Request for Information

Date: April 2, 2021
To: Newport-Mesa Unified School District
Attention: Jonathan Geiszler
Project: Estancia High School Locker Rooms Bid # 113-21
RFI #: 001

NMUSD ESTANCIA HS LOCKER ROOMS

SK-1

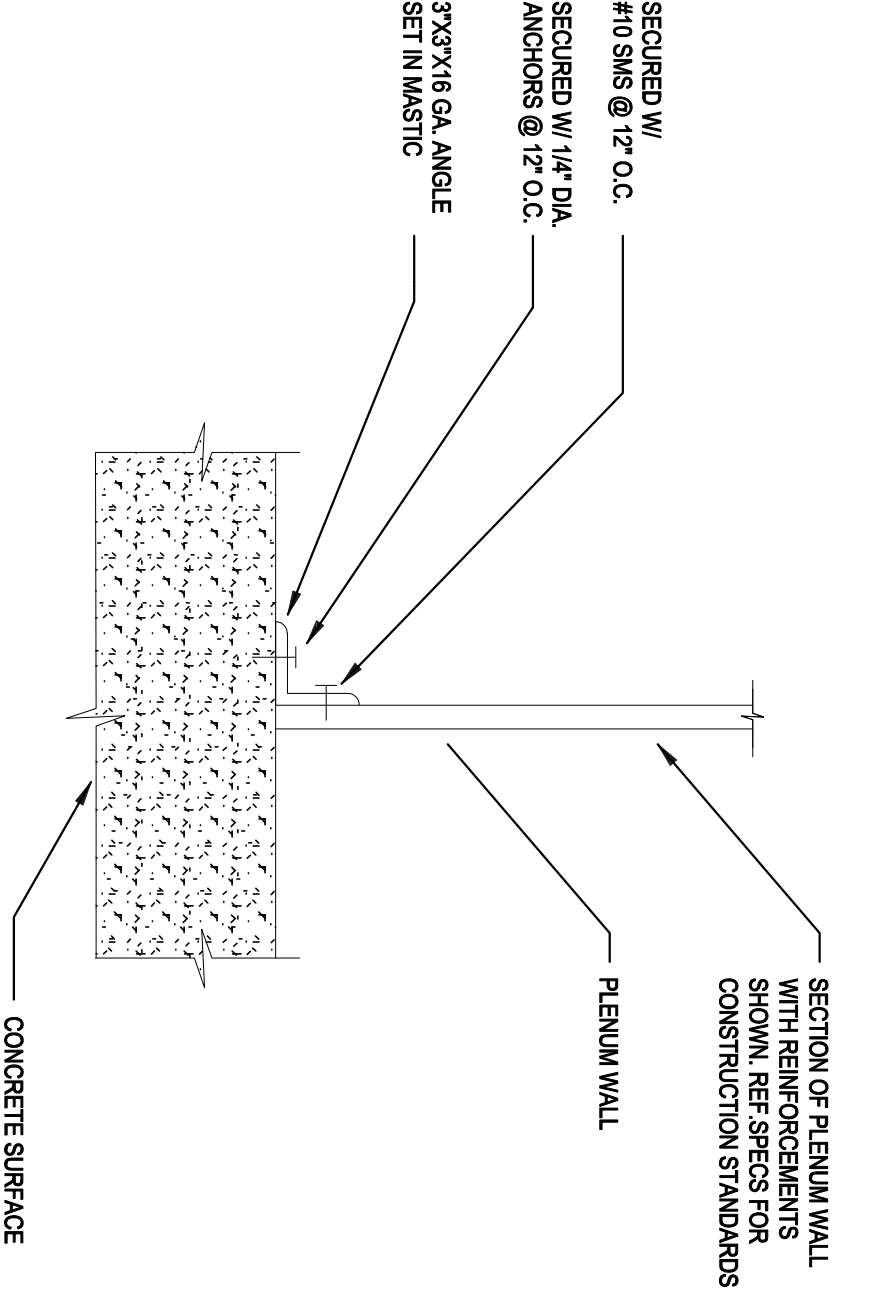
On sheet MP2.01, Keynote 7 calls for full height sheet metal plenums are shown to be installed in the mechanical rooms, but no construction or attachment details are shown. Please provide construction and attachment details.

Please reference "low velocity metal ductwork" construction as indicated in division 23 of the specs for plenum walls.

For attachment, please reference SK-1 of this PRE-BID-RFI response.

SHEET METAL PLENUM ATTACHMENT AT MECHANICAL ROOMS SERVING BOYS AND GIRLS LOCKER-ROOMS
